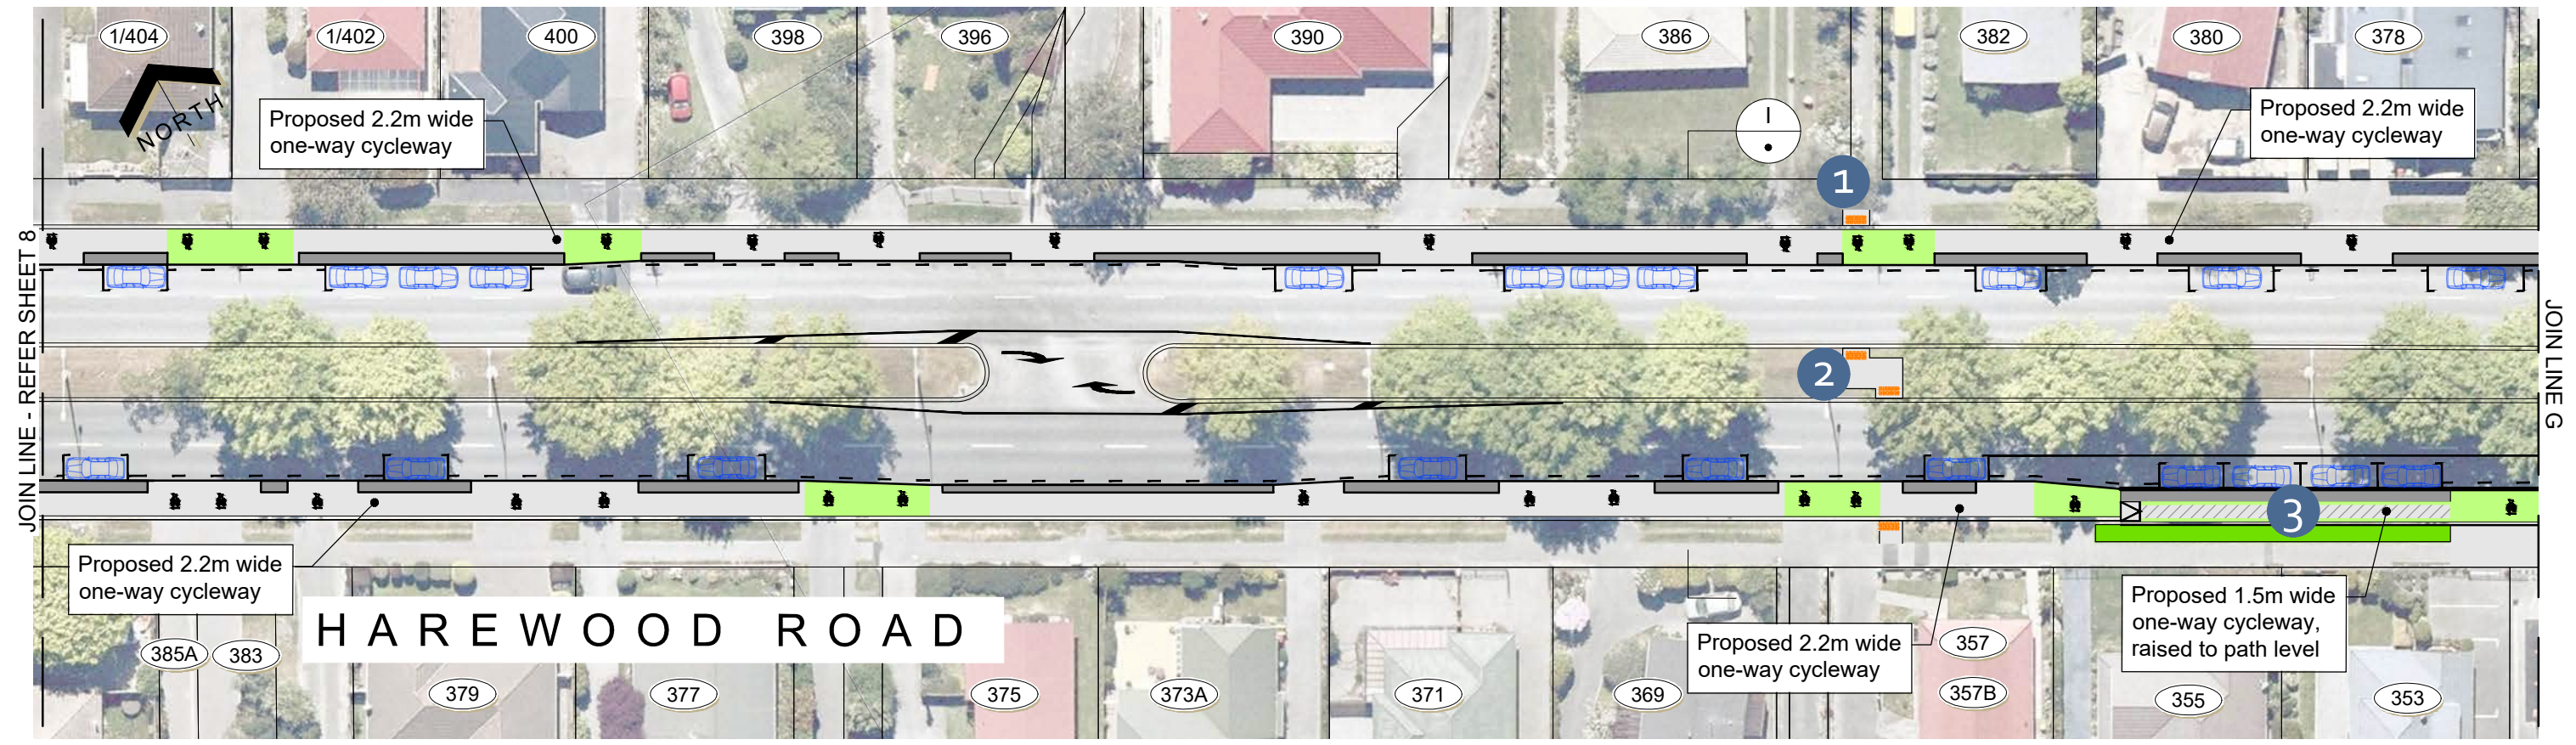
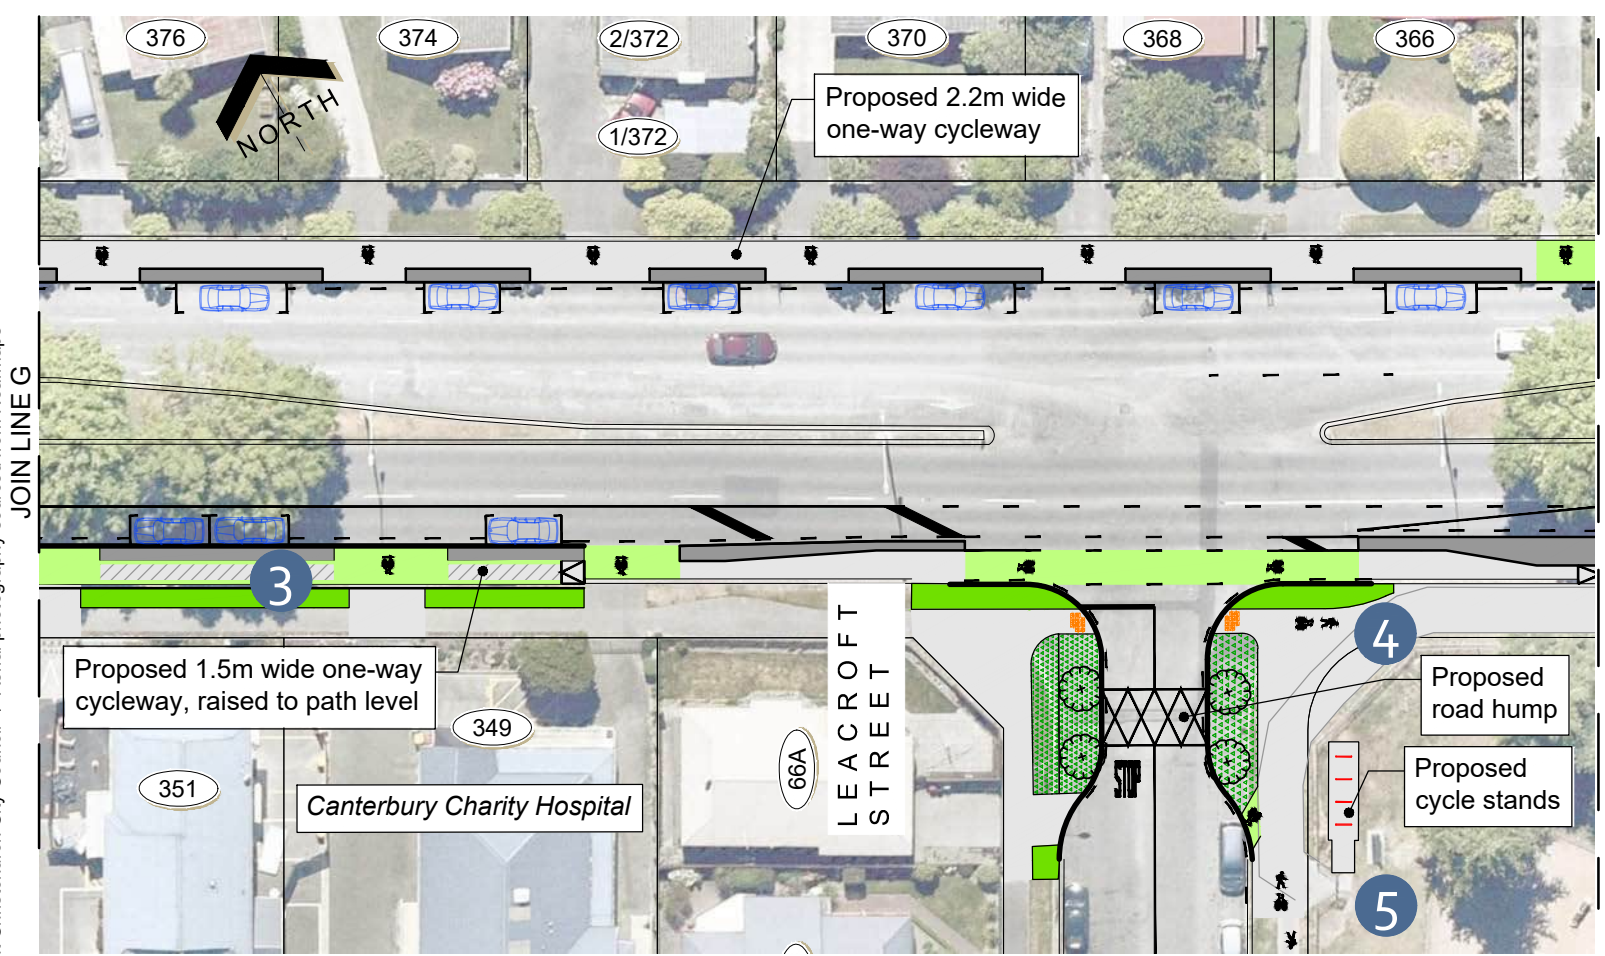
- Proposed design changes following consultation:**
- 1 A direct crossing to the cycleway from the alleyway between No. 382 and 386 Harewood Road is added.
 - 2 A pedestrian crossing point is added to the central median.
 - 3 The cycleway outside the Charity Hospital is realigned, narrowed and raised to footpath height. The existing driveways are also widened.
 - 4 A shared path area with access to Leacroft Street improves the connection on and off the cycleway to the surrounding area. Cycle stands are added near the playground on Leacroft Street.
 - 5

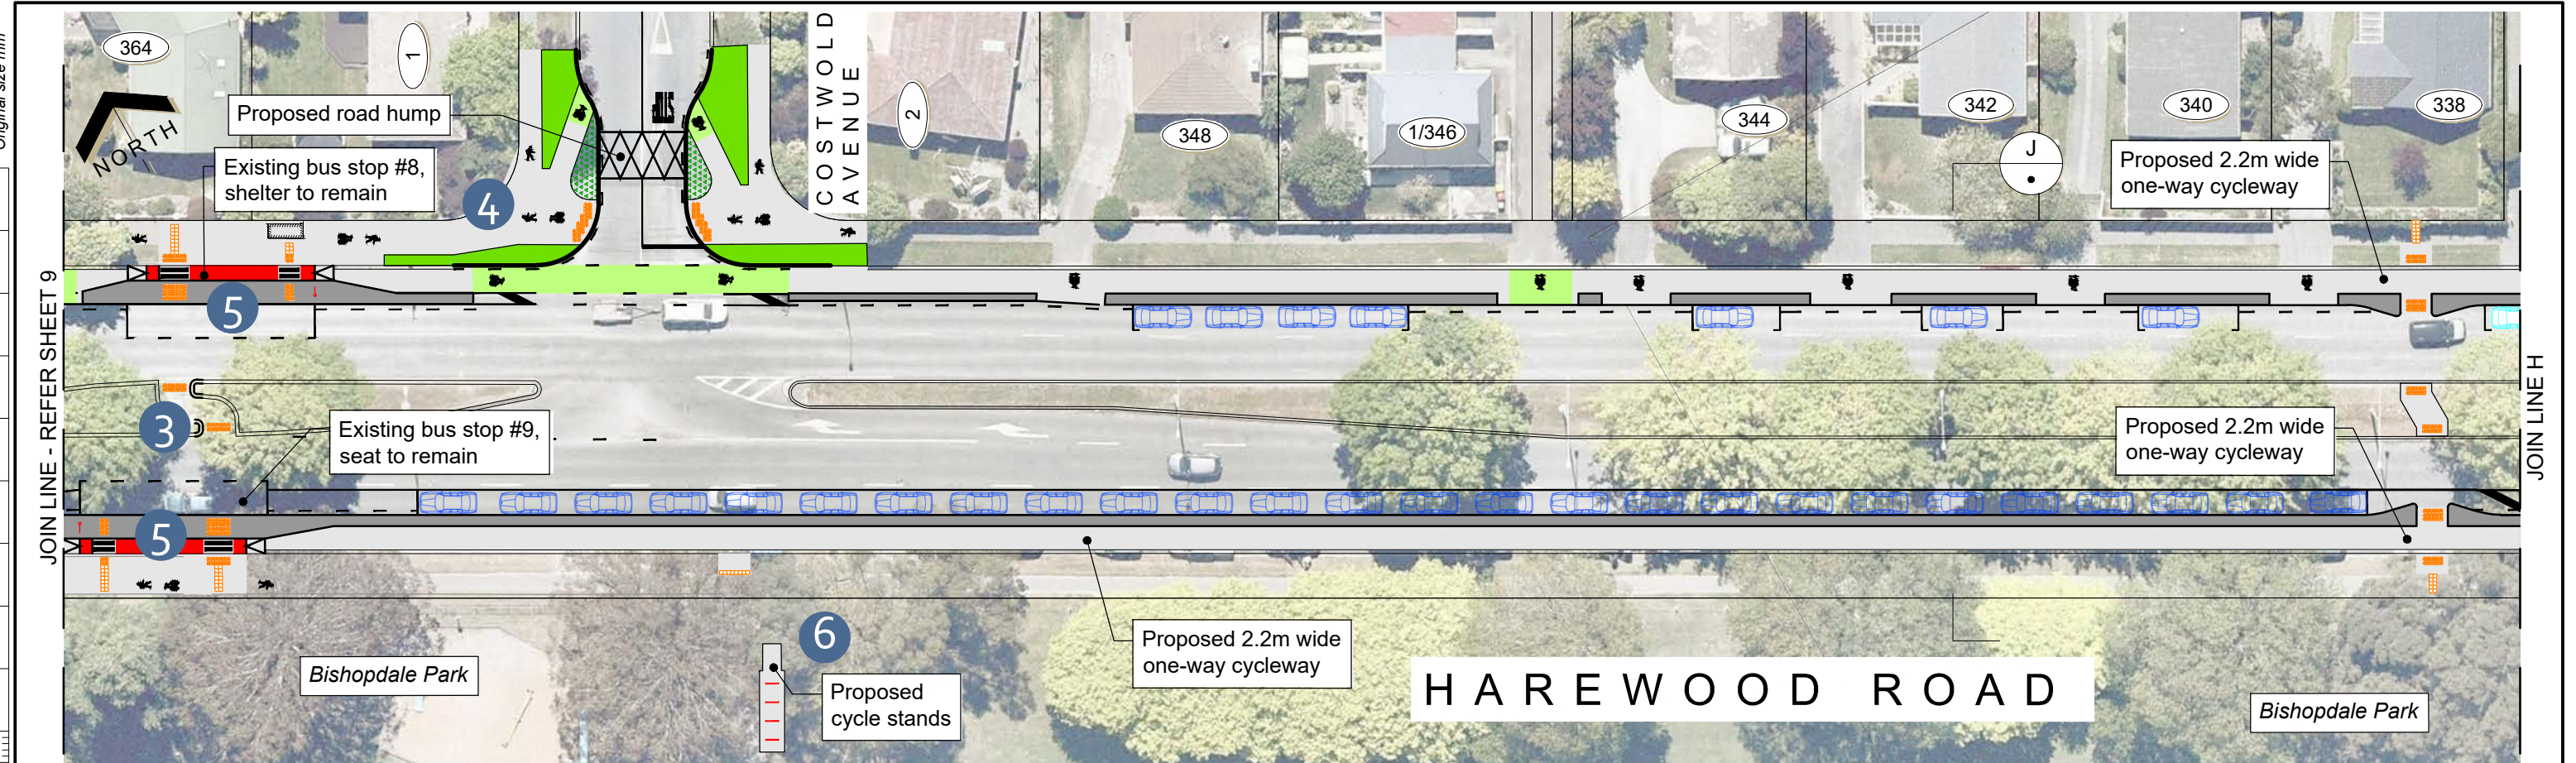
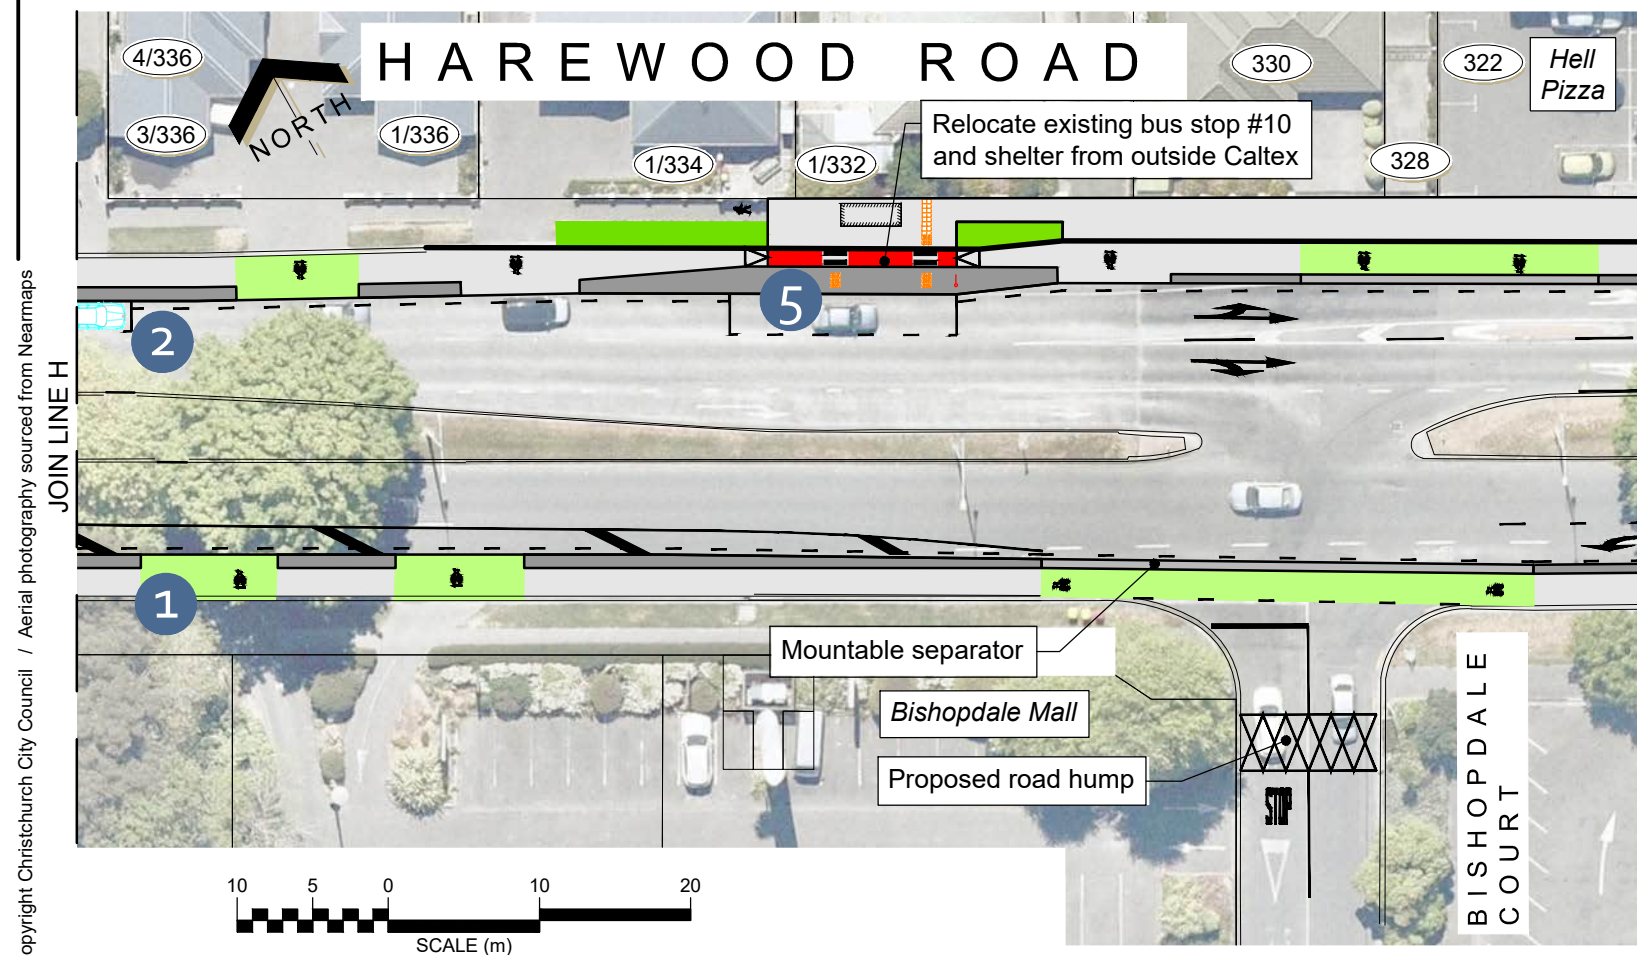
- Proposed design changes following consultation:**
- 1 The maintenance gate into the eastern side of Bishopdale Park is widened.
 - 2 An additional on-street parking space is provided outside No. 338/336 Harewood Road.
 - 3 The crossing through the central median is widened to make it easier to use.
 - 4 A shared path area with access to Cotswold Avenue improves the connection on and off the cycleway to the surrounding area.
 - 5 The platform for the bus stops outside Bishopdale Park, No. 364 and No. 332 Harewood Road are widened to approximately 1.8 m. The cycleway is narrowed at these locations.
 - 6 Cycle stands are added near the elephant slide.

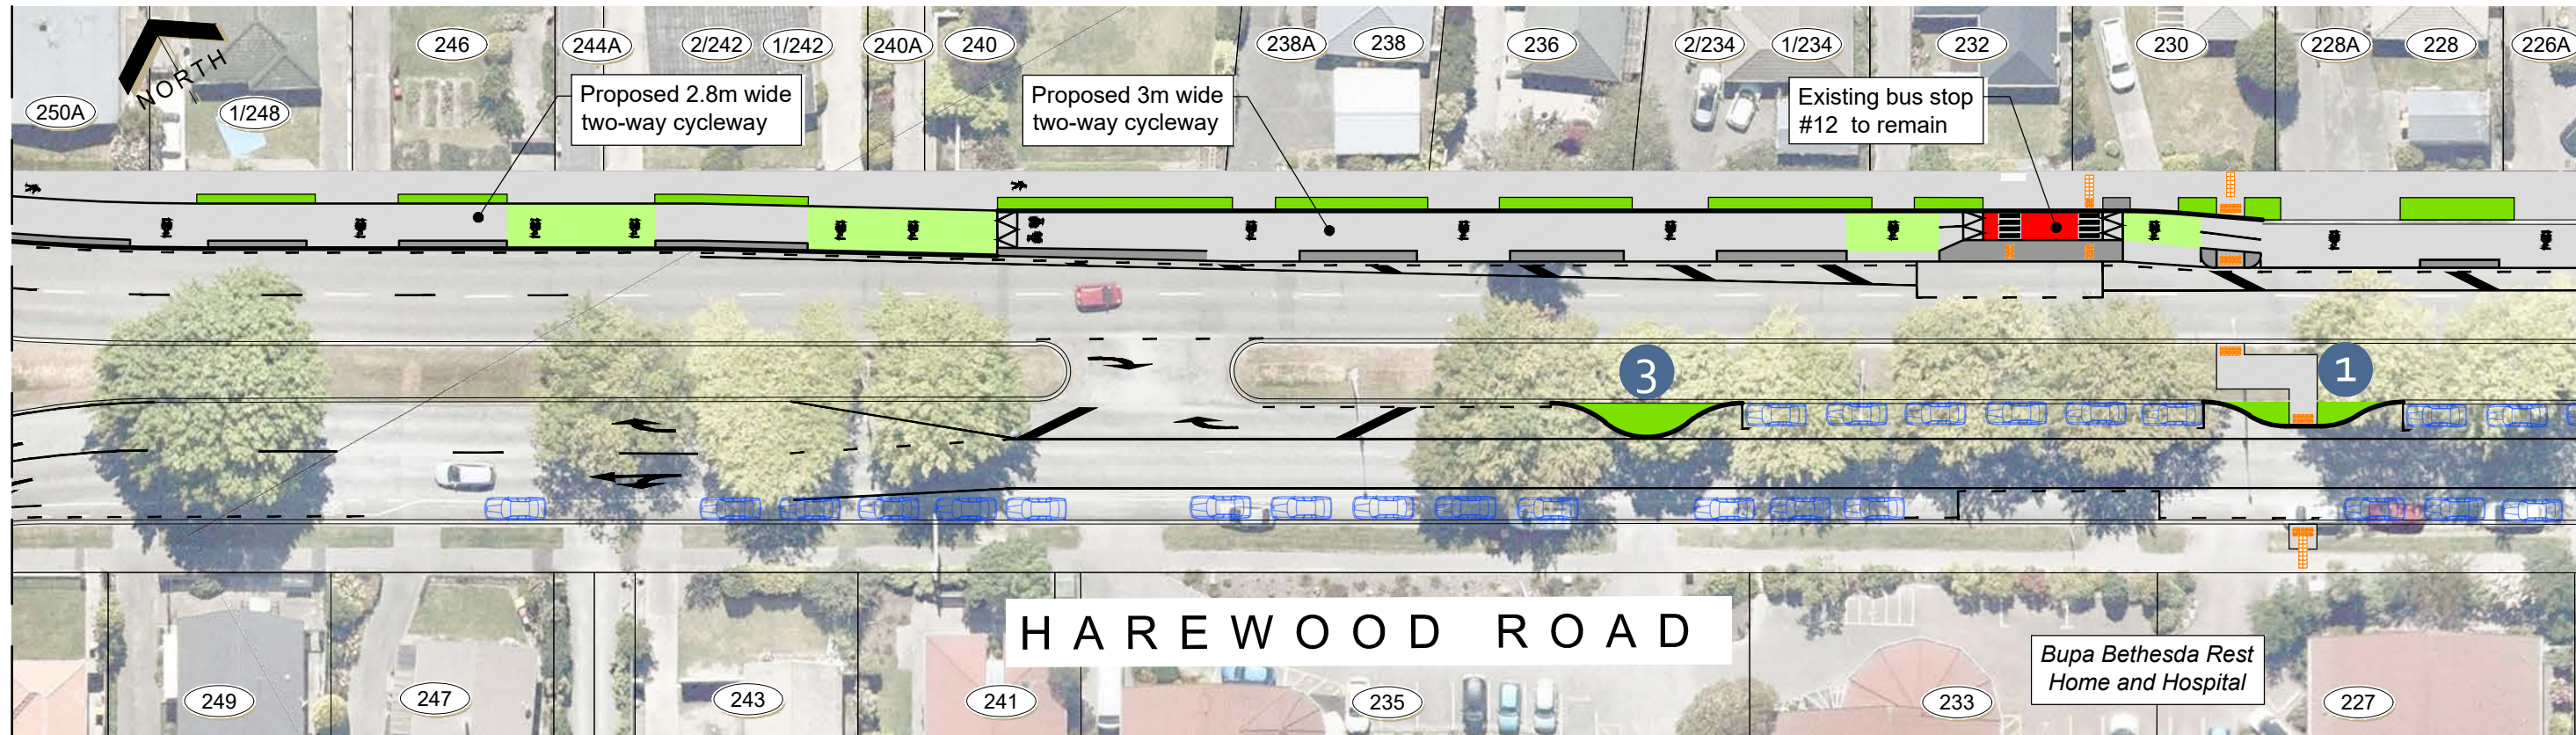
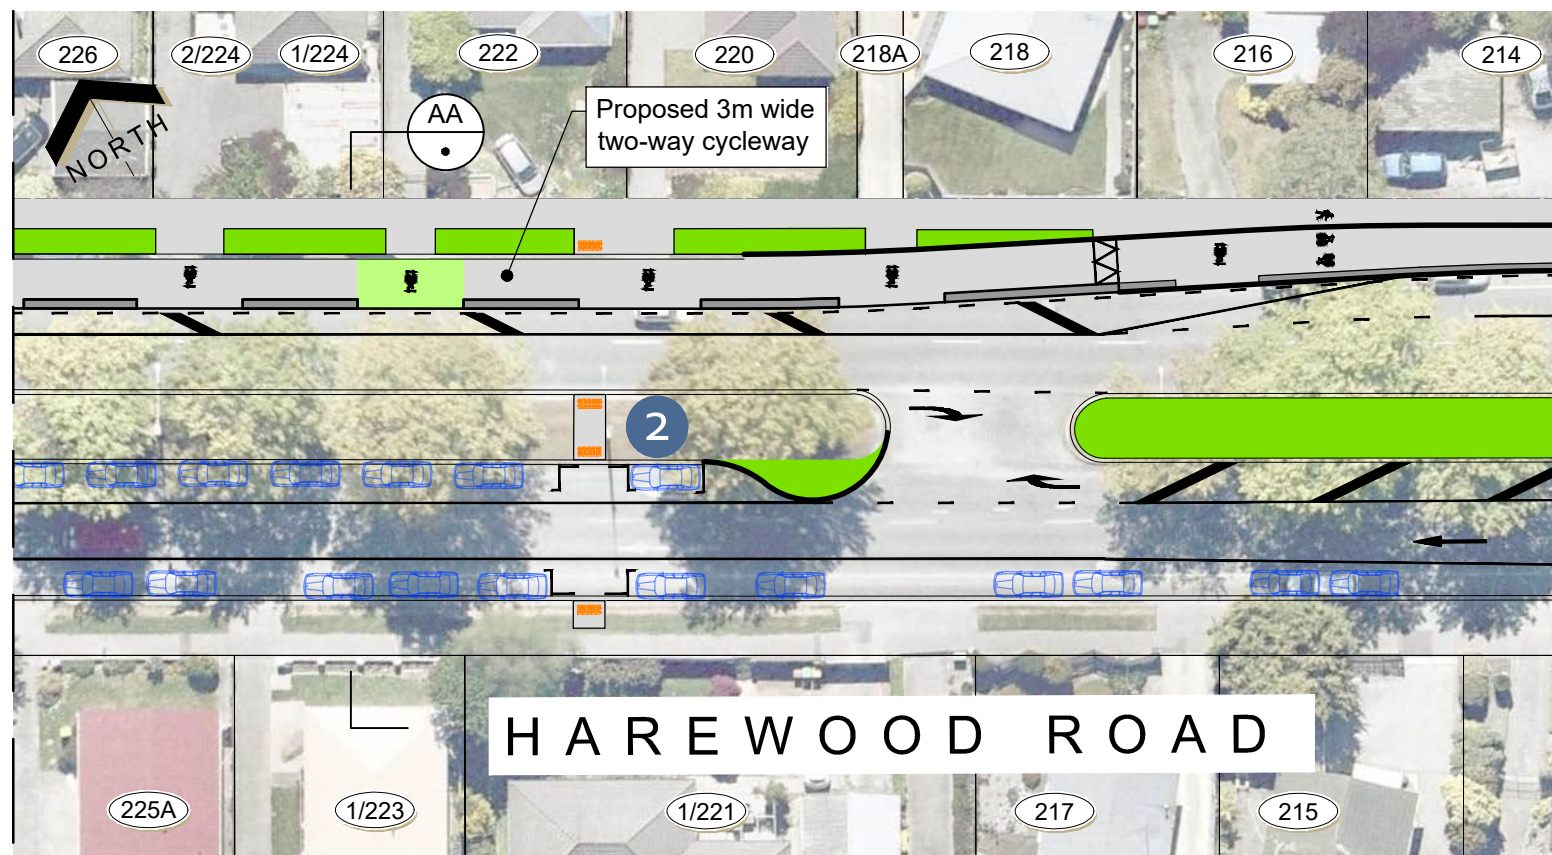
- Proposed design changes following consultation:**
- 1 A crossing point through the central median is added outside Bethesda Rest Home.
 - 2 A crossing through the central median outside No. 221/222 is provided to access the on-street parking adjacent to the median.
 - 3 A kerb buildout adjacent to the central median is added at the end of the on-street parking.
